## CITY OF ST. HELENS PLANNING DEPARTMENT

**TO:** City Council and interested parties  
**FROM:** Jacob A. Graichen, AICP, City Planner  
**RE:** Appeal AP.1.22 Record for continued deliberations  
**DATE:** August 18, 2022

**REVISED PRELIMINARY  
PLAT SUBMITTED 8.15.22**

**ZONING:** Moderate Residential, R7  
**LOCATION:** 4N1W-6D-604 and 4N1W-6AD-2600  
**PROPOSAL:** 46 lot Planned Development Subdivision Preliminary Plat

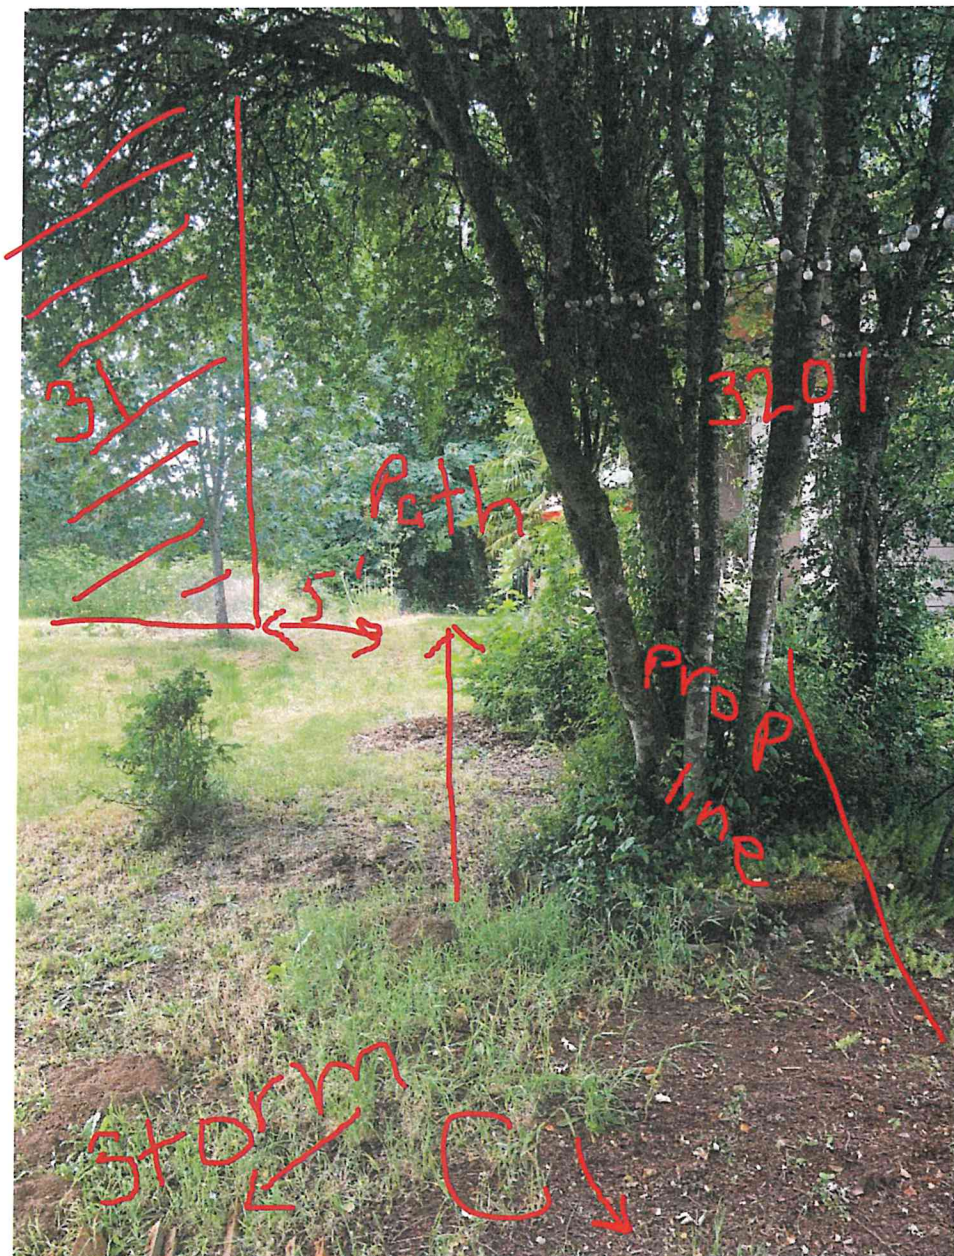
Lastly as a general inquiry regarding the creation of South Lane (middle & south) map. Currently Parcel 1, which includes 3 tax lots, accesses the residences directly from Barr Avenue via a private driveway. The new right of way creating a public access road will change the residential access via the easement driveway from Barr to the newly named South Lane. Does the city expect this to affect the mailing addresses of the existing 3 residences of Parcel 1? Removal of the mailbox for the three residences will be removed from Barr Ave. during the creation of the new road. What is the expectation for the homeowners in Parcel 1 regarding mail delivery during construction and reinstallation of the mailboxes post construction?

A. Wildlife currently traveling from Storm C to Open Area south end flanking Parcel 1

B. Storm C off of Barr Ave. flanking Parcel 1, Existing trees on property line

C. Proposed wildlife pathway,  
retains existing trees

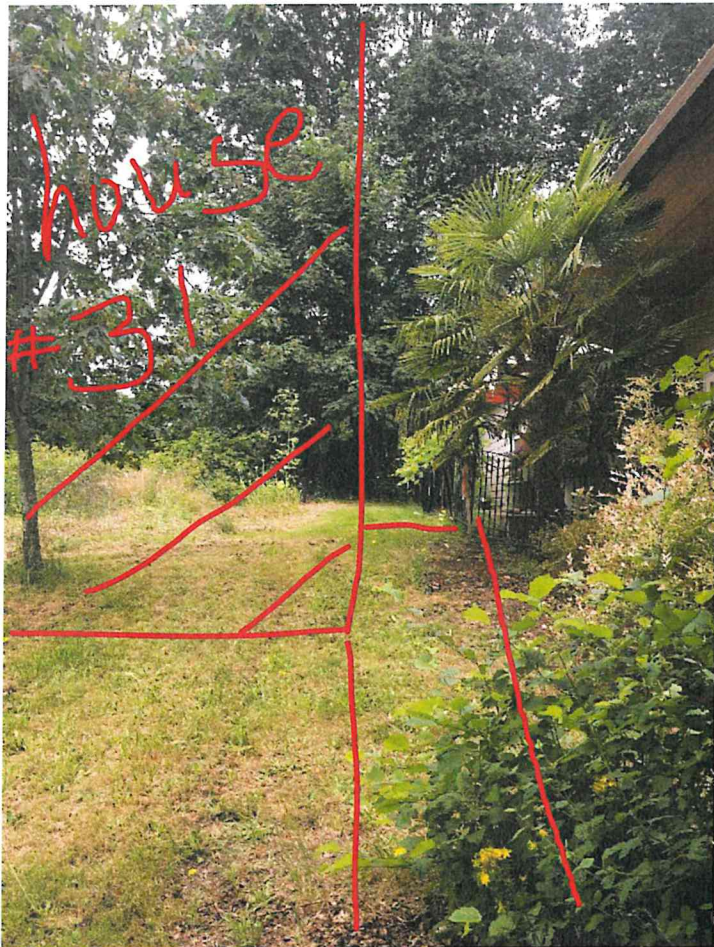
**E.** Side of Lot 31 will have a significant effect on privacy of Parcel 1, tax lot 3201. Adding wildlife pathway will increase perception of distance between side setback

**F.** Side of Lot 31 will have a significant effect on privacy of Parcel 1, tax lot 3201. Adding wildlife pathway will increase perception of distance between side setback
